UNITED STATES DISTRICT COURT  
FOR THE DISTRICT OF CONNECTICUT

UNITED STATES OF AMERICA, et al.,	:	Civil Action No. H-79-704 (JAC)
Plaintiffs	:	
v.	:	Superfund Records Center
SOLVENTS RECOVERY SERVICE OF NEW ENGLAND, INC.,	:	SITE: <u>SRS</u> BREAK: <u>10.9</u> OTHER: <u>550387</u>
Defendant	:

CERTIFICATION OF JAMES R. HULM

FIGURE 1

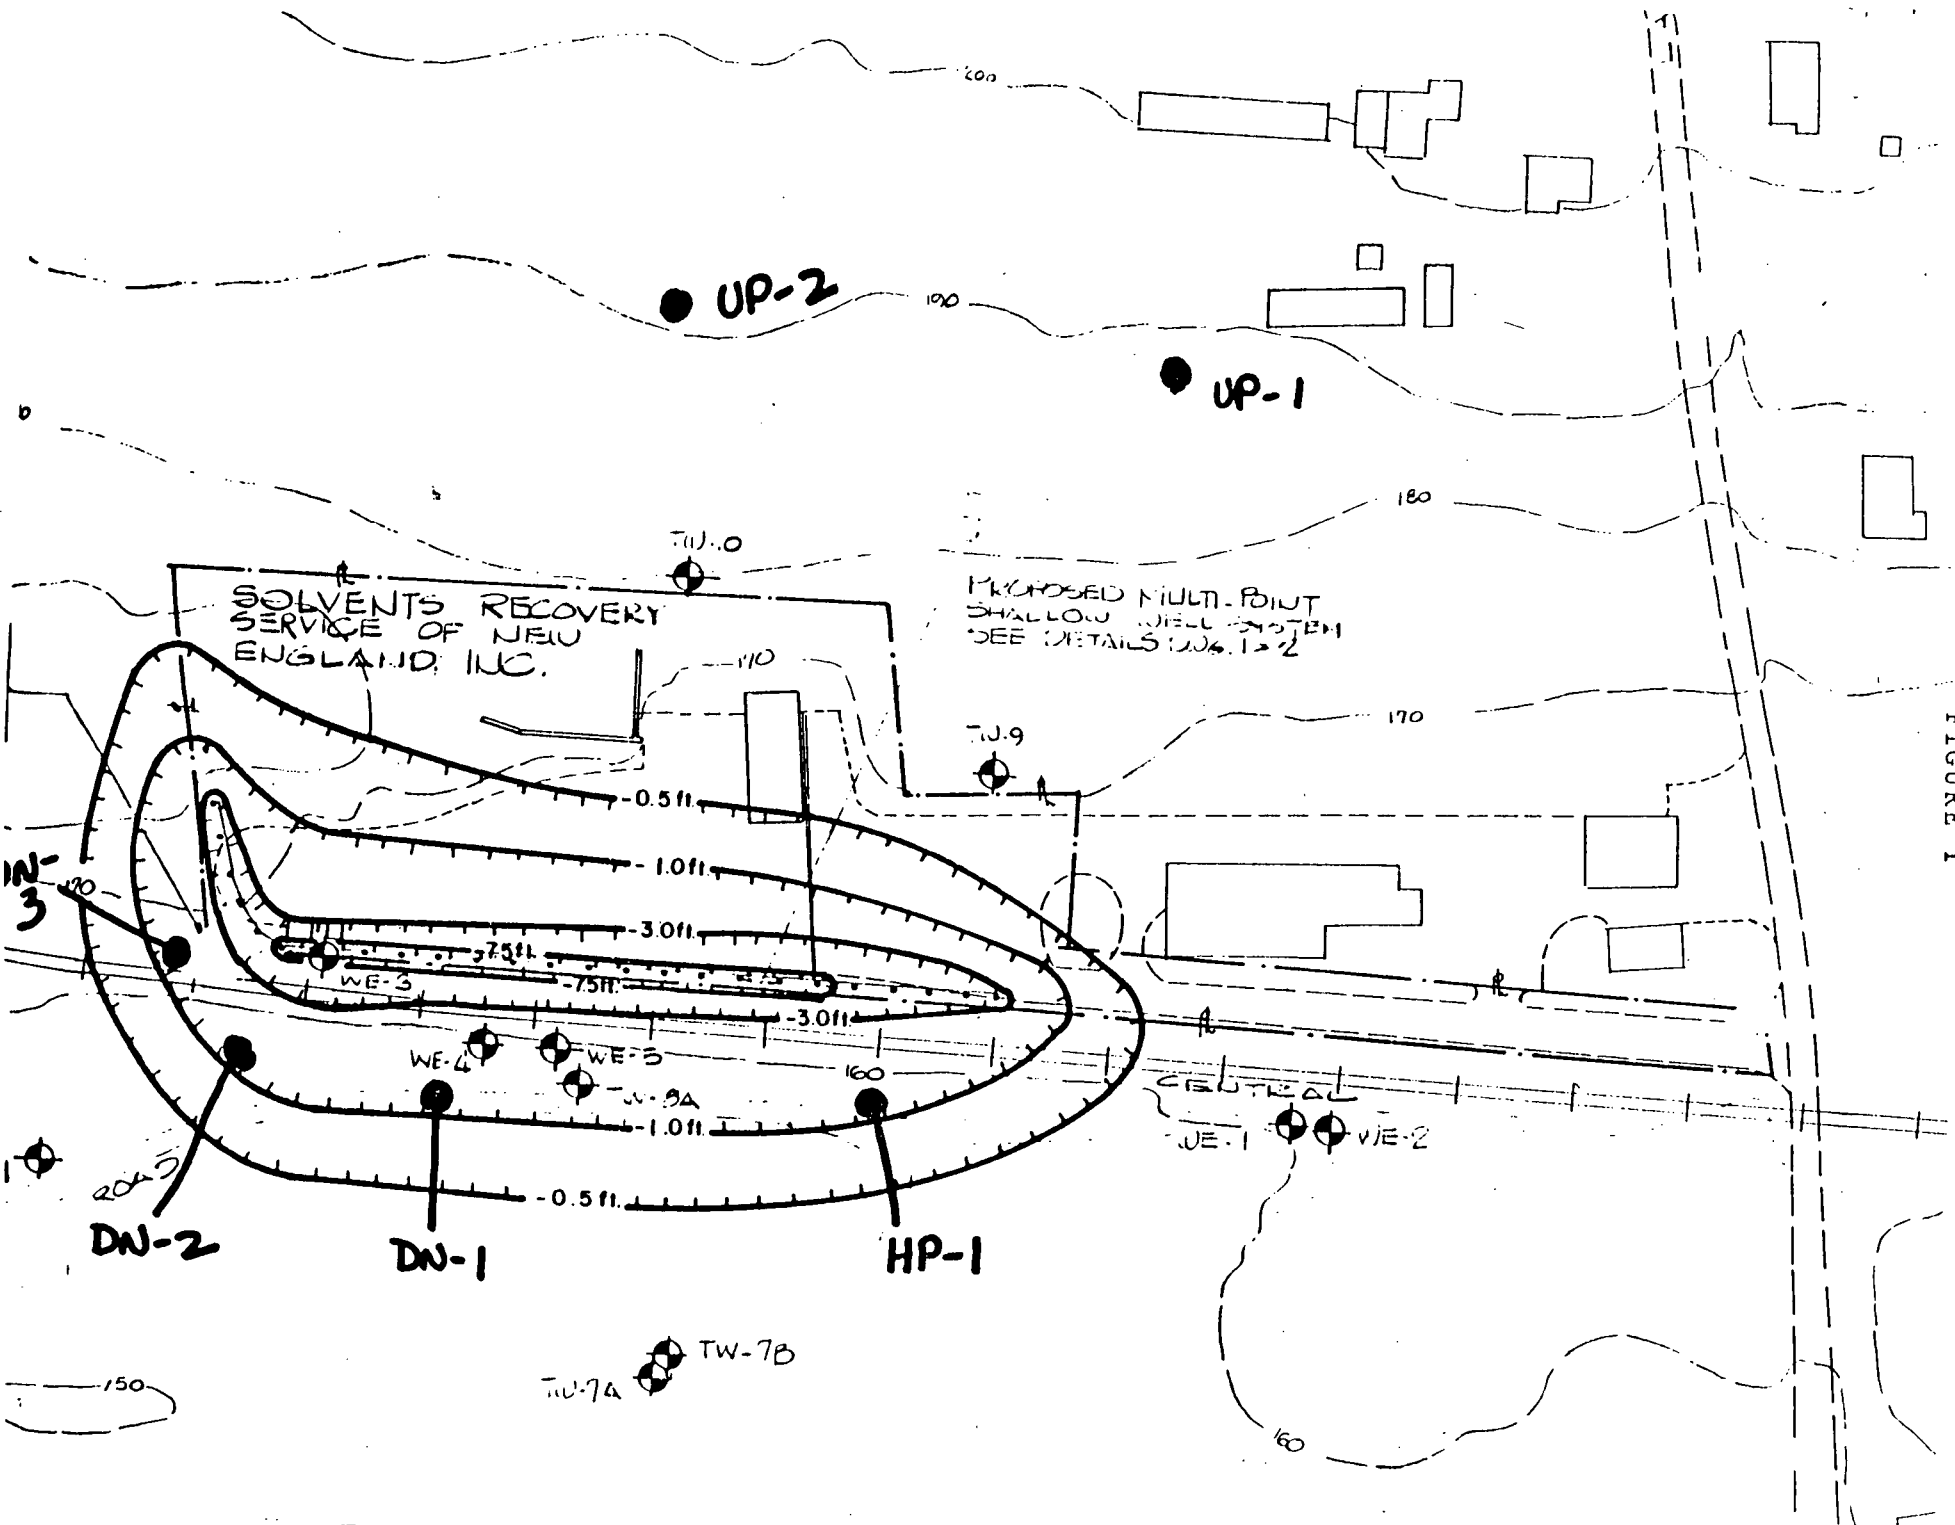
- ° Relocate wells DN-1, DN-2, and DN-3 as shown on the attached Figure 1 to provide for a broader area for both hydraulic performance verification and water quality measurement.

- ° Install an additional water table piezometer in the northeast portion of the cone of depression, as shown by well HP-1 on Figure 1.
- ° In conjunction with EPA and its consultants, agree on the approximate locations of all new monitoring wells in the field and mark these locations with surveyor's stakes or other devices.

Finally, the EPA is also concerned about the location of the upgradient monitoring wells. As proposed in the revised report, UP-1 is much too far north and east to be upgradient of SRSNE and UP-2 is too far north. To fulfill the intent of the Consent Decree, SRSNE should change the proposed locations of the upgradient monitoring wells UP-1 and UP-2 to the approximate locations shown on Figure 1. At a minimum, UP-1 must be moved farther west.

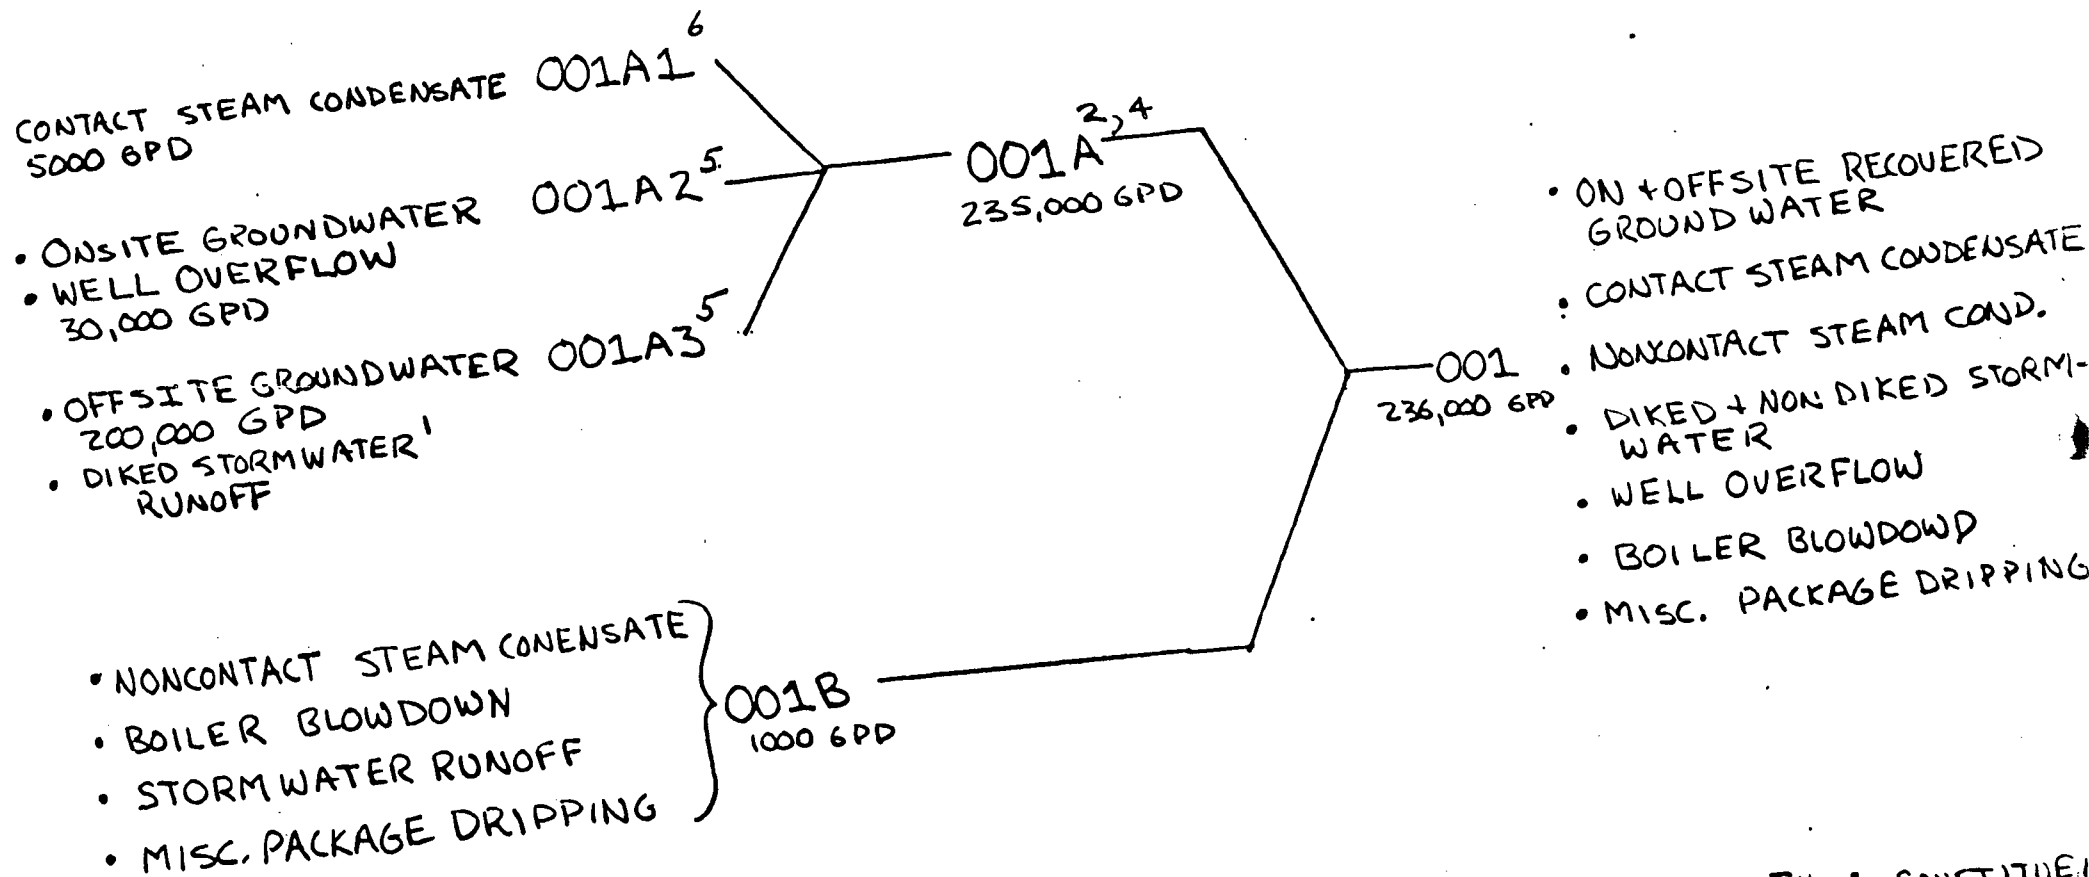
1. ITEM 4 ON PAGE 6 OF THE PERMIT REQUIRES DIKED STORMWATER TO BE TREATED, THIS CONSTITUTE SHOULD BE ADDED TO EITHER OUTFALL 001A1 OR 001A2 AS WELL AS 001A.
2. WELL OVERFLOW IS MISSING FROM LIST OF 001A CONSTITUENTS.
3. MISC. PACKAGE DRIPPING IS MISSING FROM LIST OF 001 CONSTITUENTS.
4. EFFLUENT LIMITATIONS ARE ESTABLISHED HERE.
5. INFLUENT/EFFLUENT MONITORING HERE.
6. EFFLUENT MONITORING HERE.
